ADDENDUM NO. 1

Project Name:	Charlottesville-Albemarle Airport Mechanical Systems Upgrades
RS&H Project Number:	20541892009

DATE OF ISSUANCE: June 28, 2024

SHEET ID:
 MS101

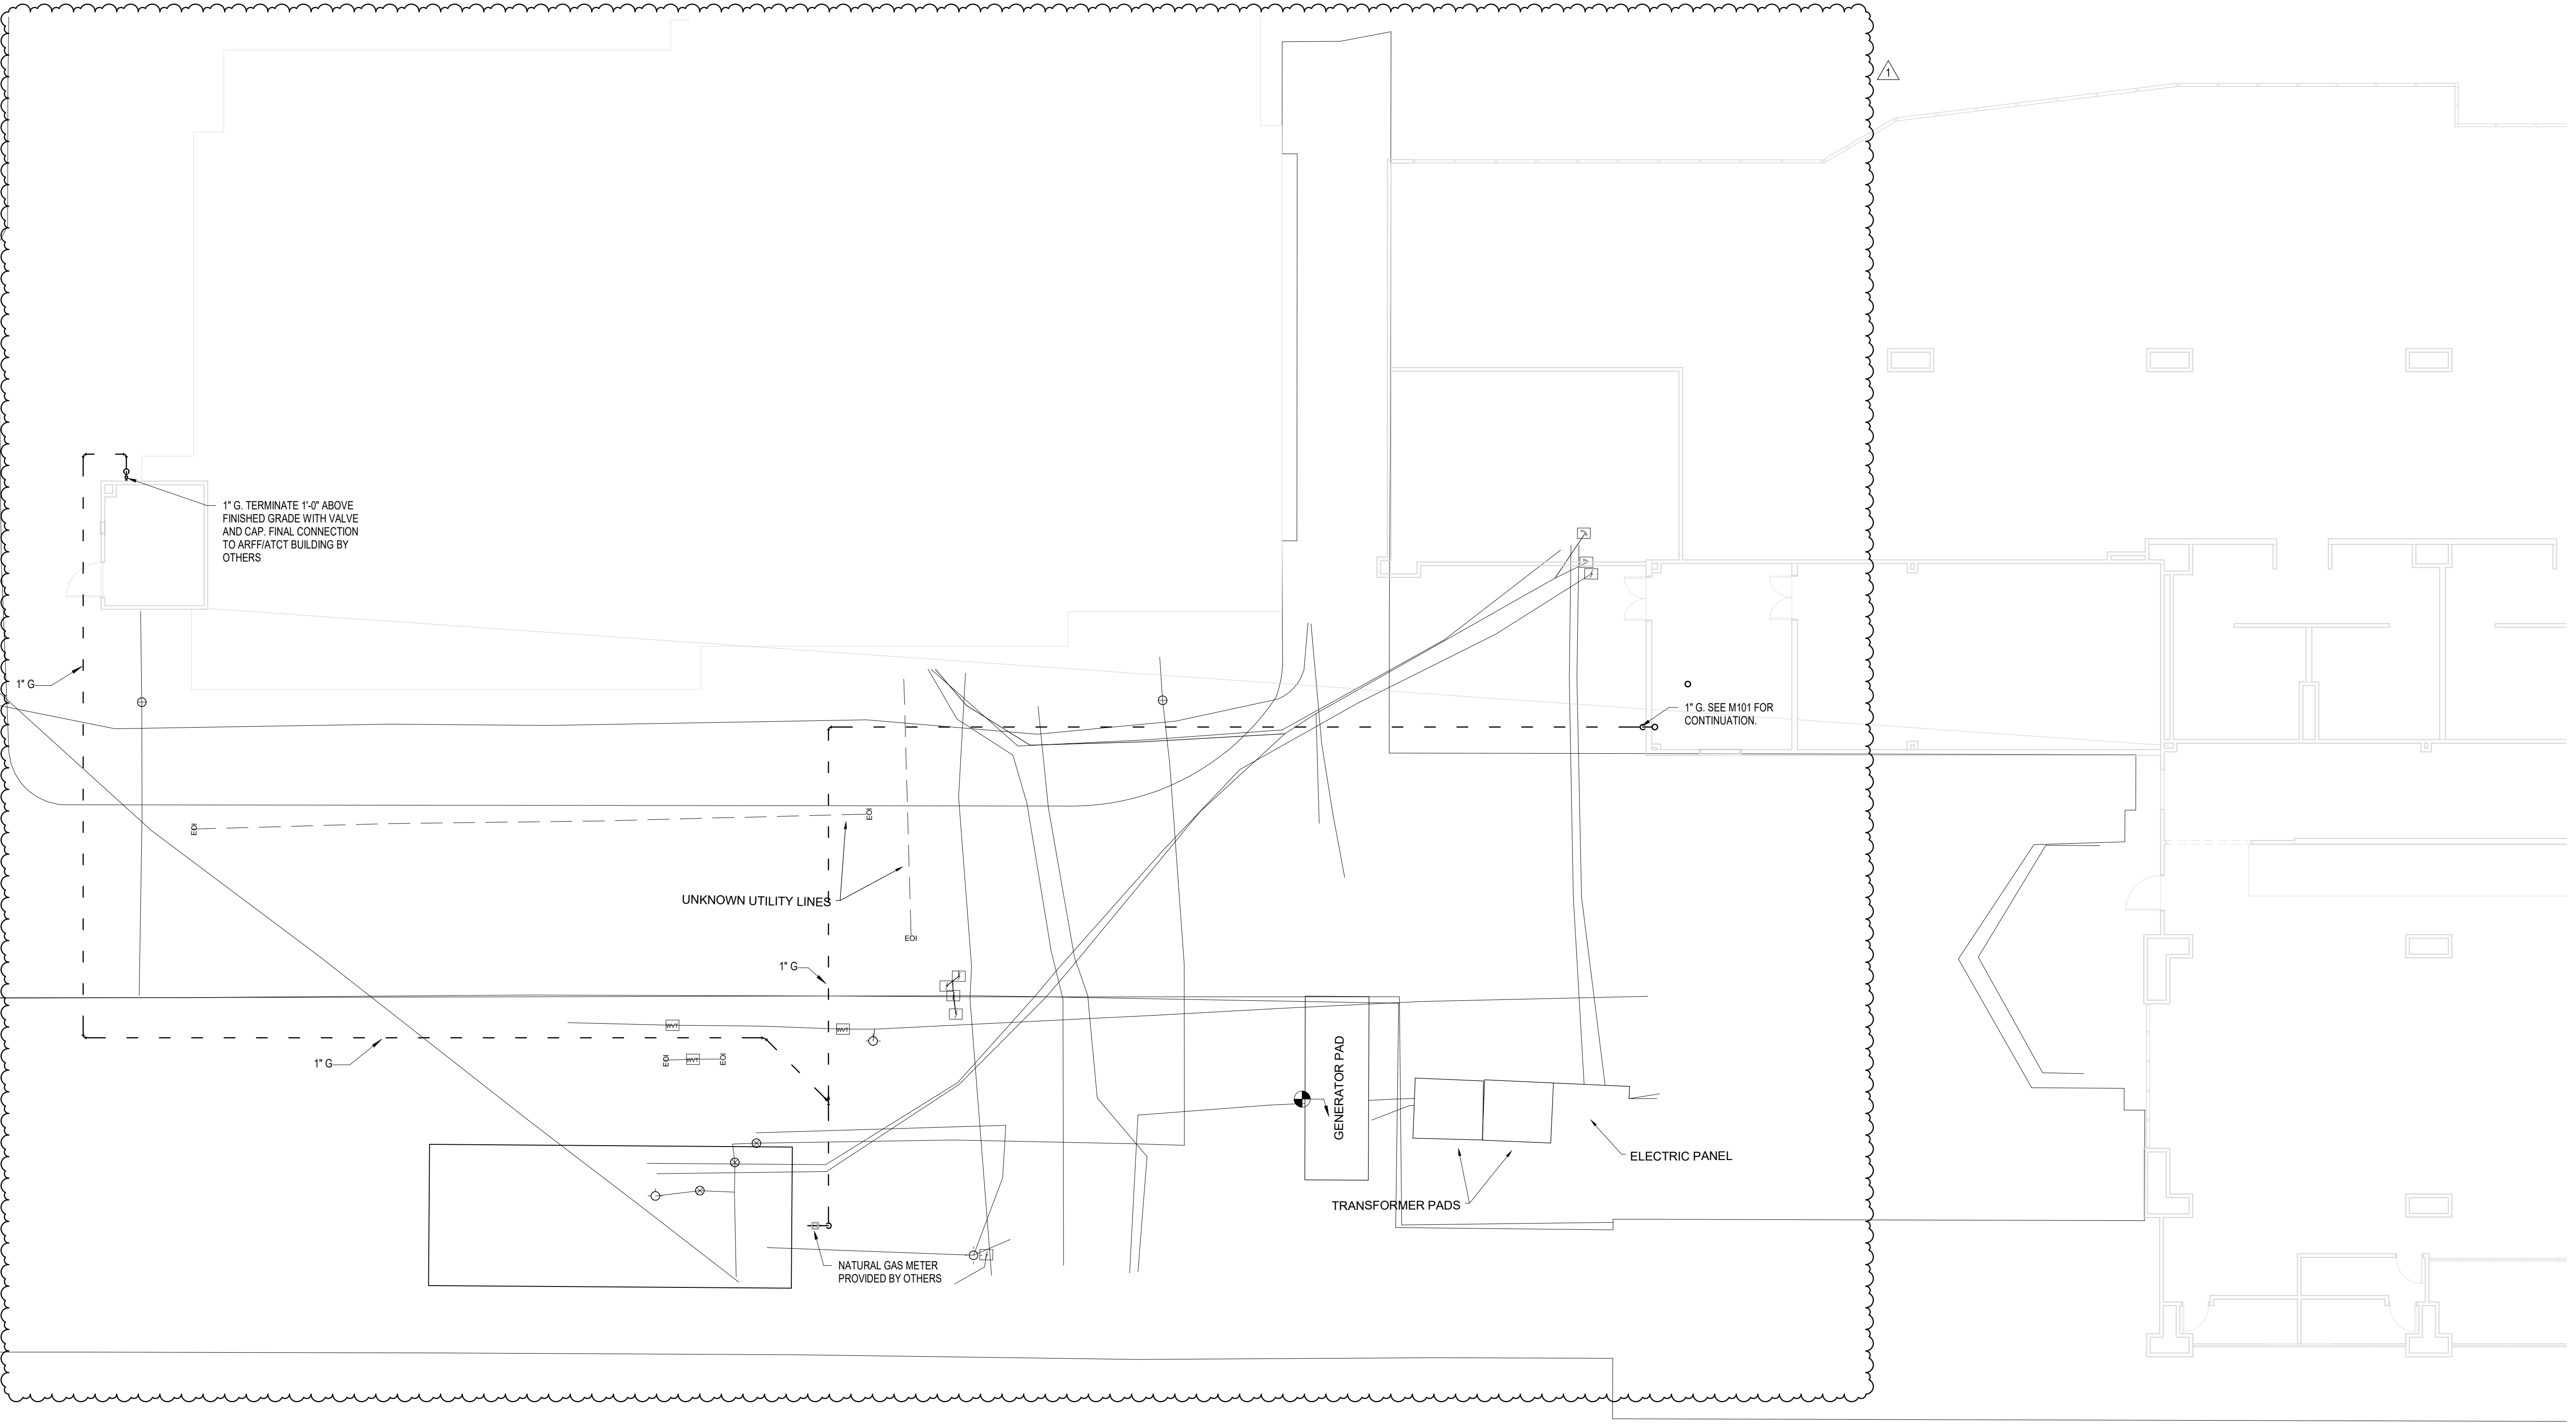
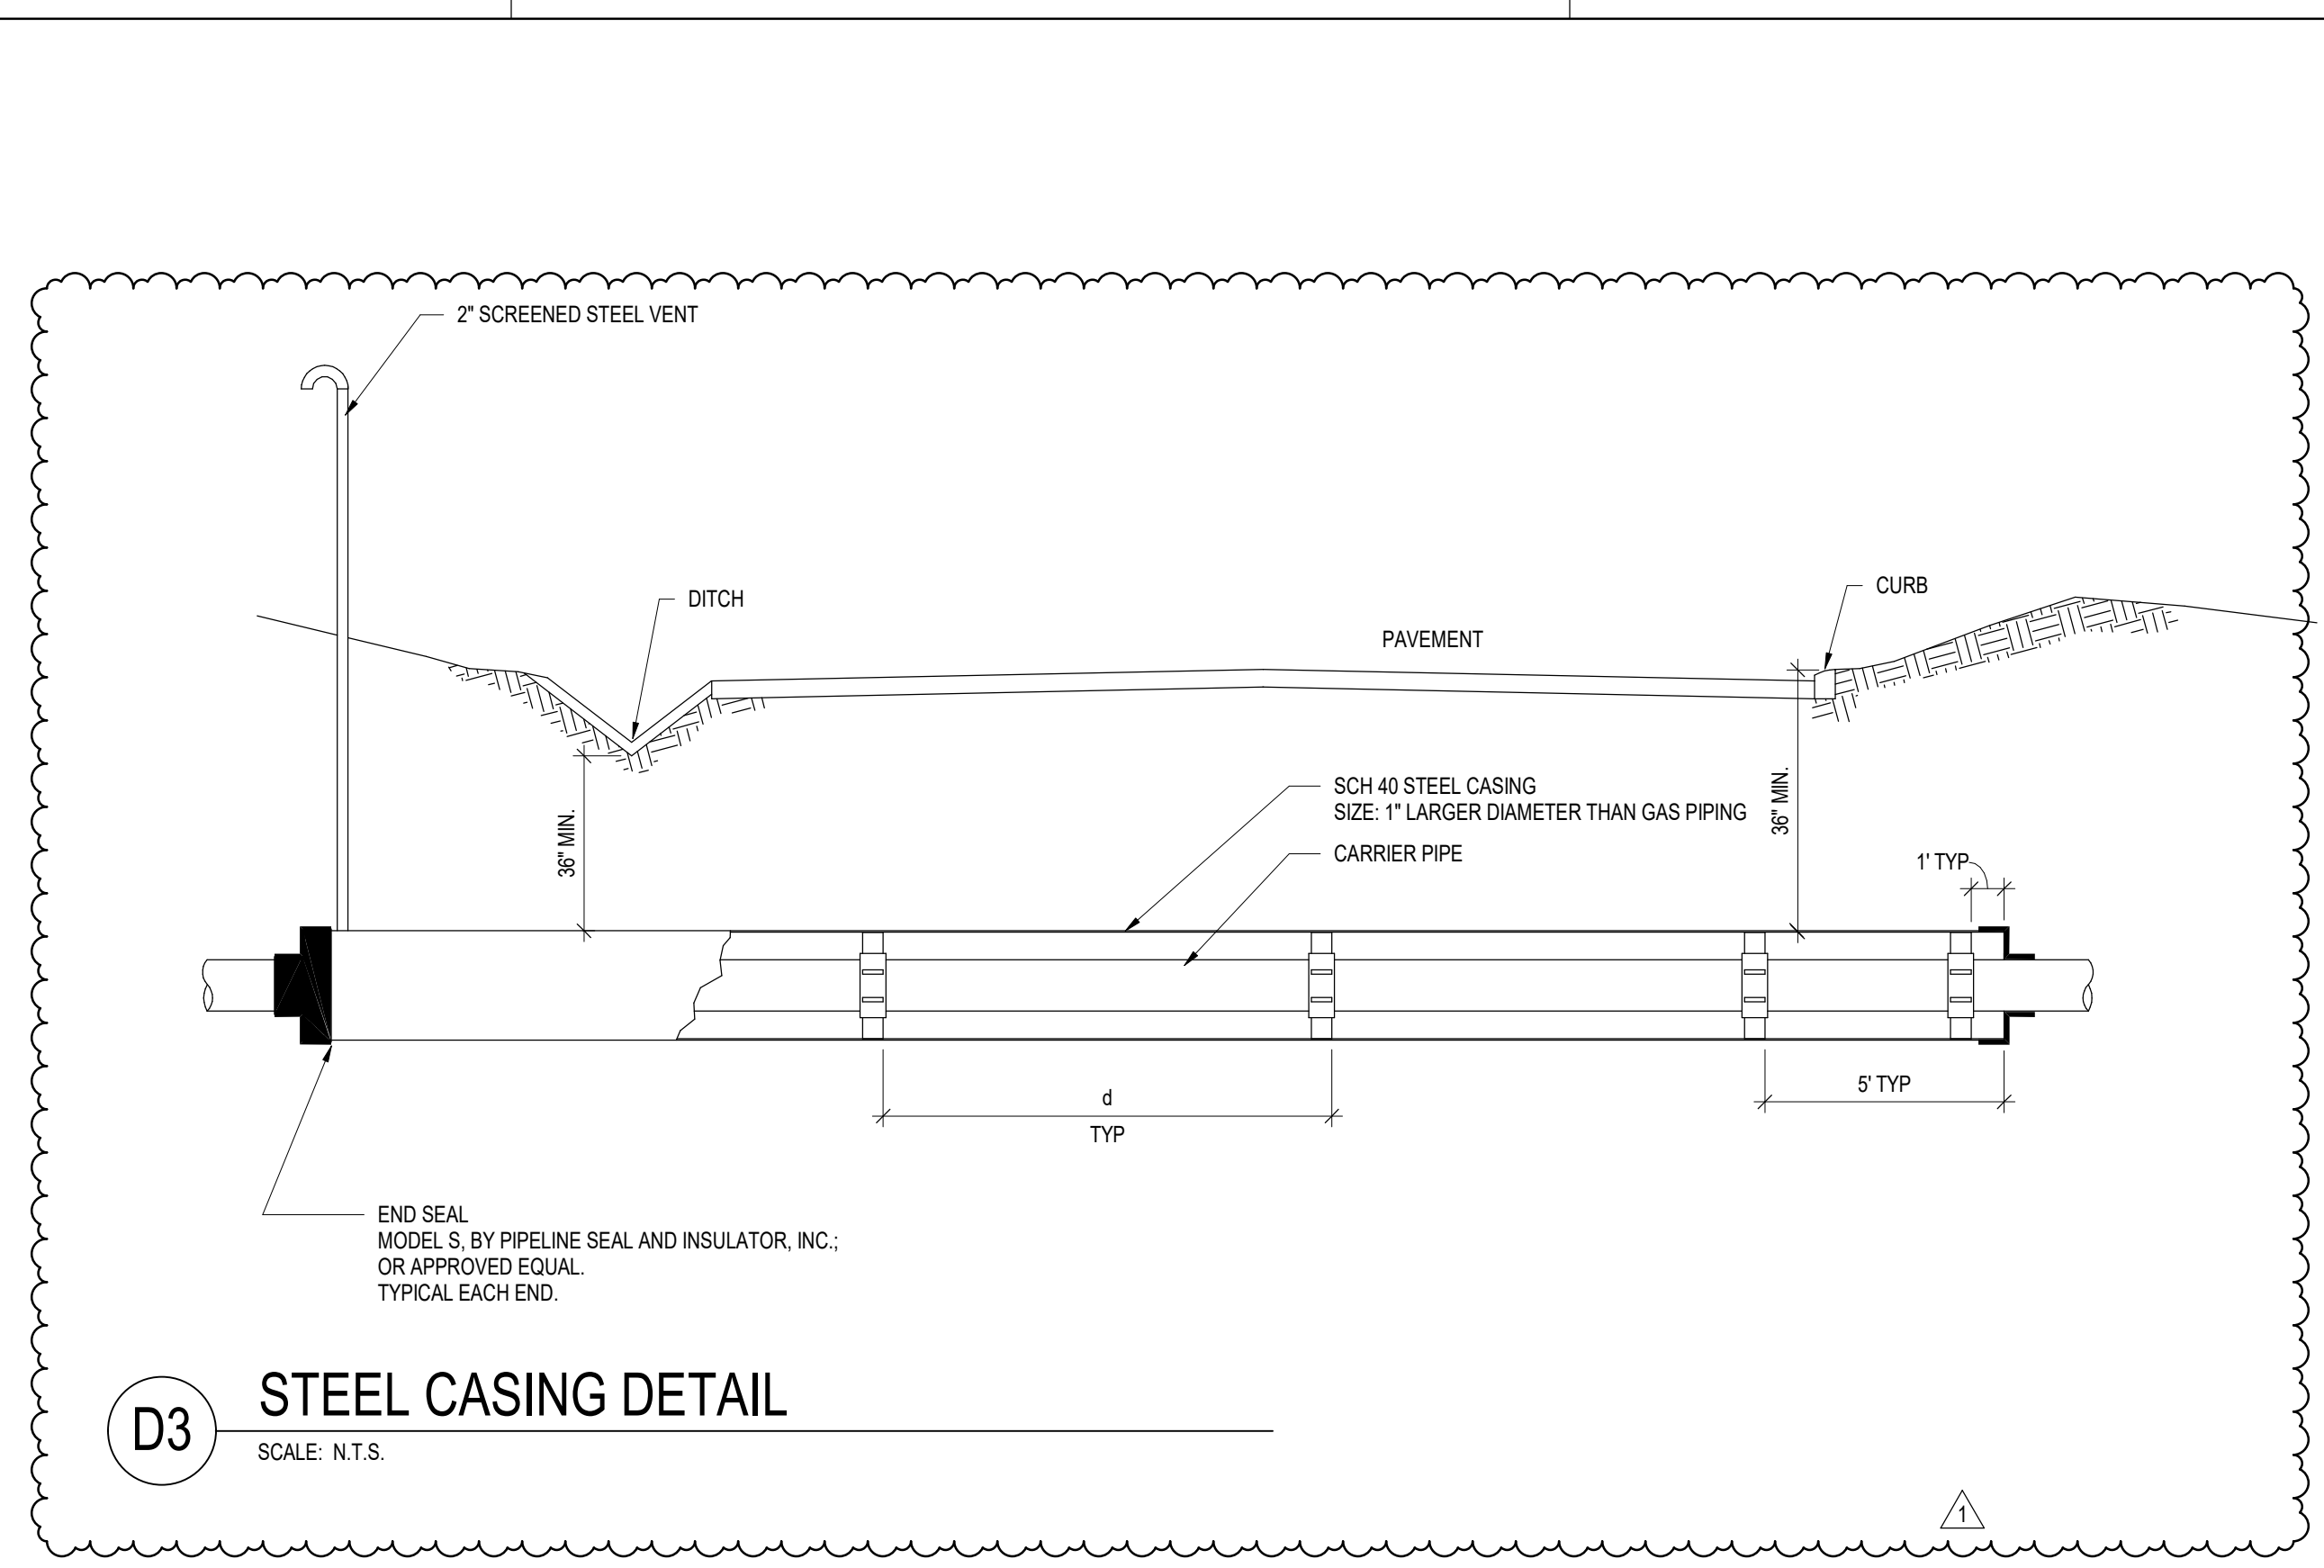
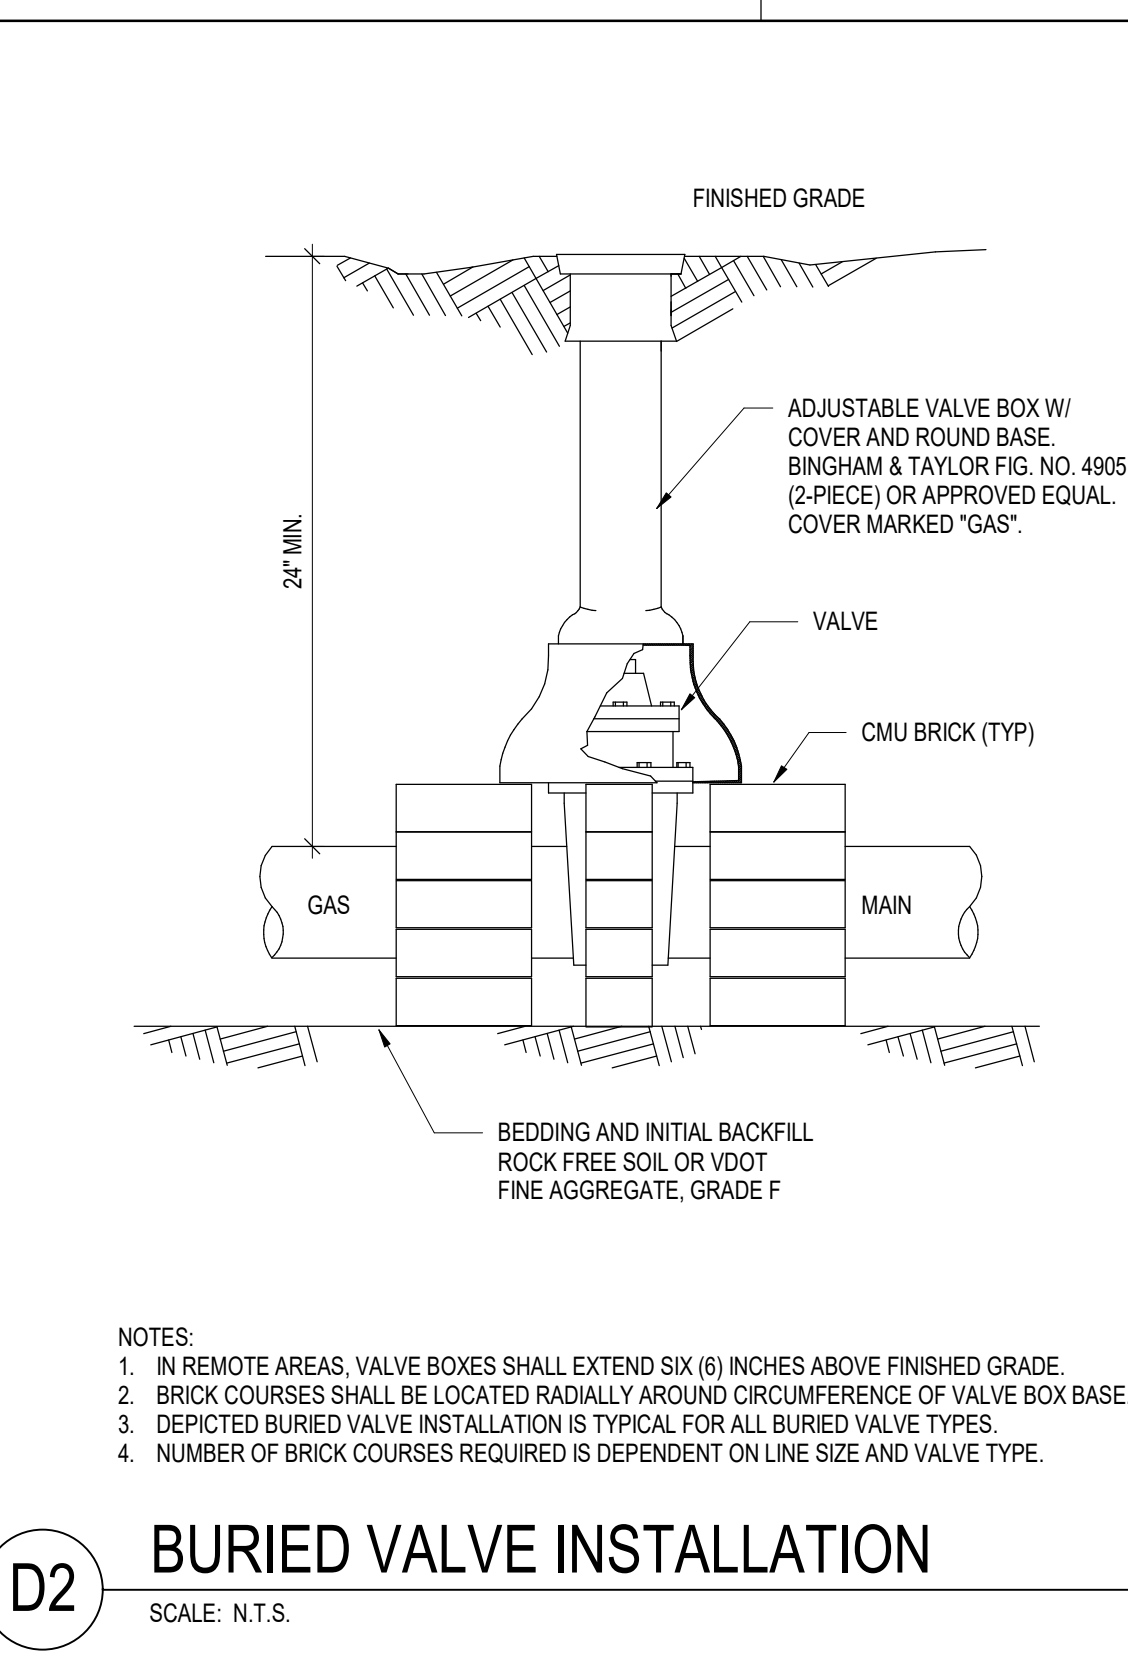
13	Drawing MS101 – Detail #1 – Shows pipe trench detail, we also need the thickness required to patch the asphalt drive, concrete walkway, and concrete apron. Also, the requirements, if any, for re-bar.	Pavement sections are as follows: a. Asphalt Drive: 4” of VDOT SM12.5 asphalt, over VDOT #21A stone to the top of the trench b. Concrete Sidewalk: 4” of VDOT 217 concrete, over VDOT #21A stone to the top of the trench c. Concrete Apron: 12” of VDOT 217 concrete, over VDOT #21A stone to the top of the trench
14	Drawing M501 – Detail A5 Air Separator, and Detail A3 Expansion Tank (ET-1), are these items existing to remain, or new? If so, where are they located, and where are the tie in locations? Also, we need a schedule for these items, listing Capacity, Size, Basis of Design etc... And do they receive insulation?	Details were applicable to a previous scope of work that has been removed. Details have been deleted. See revision in Addendum #1.

50	Would it be possible to get a little more detail on exactly where the gas line is running? Particularly on the one that runs directly towards the building before cutting to the right. For example, if it's running under the existing sidewalk and where exactly it goes into the building.	Site plan on MS101 has been updated to show pipe routing and surrounding pavement and utilities. See revision in Addendum #1.
51		
52
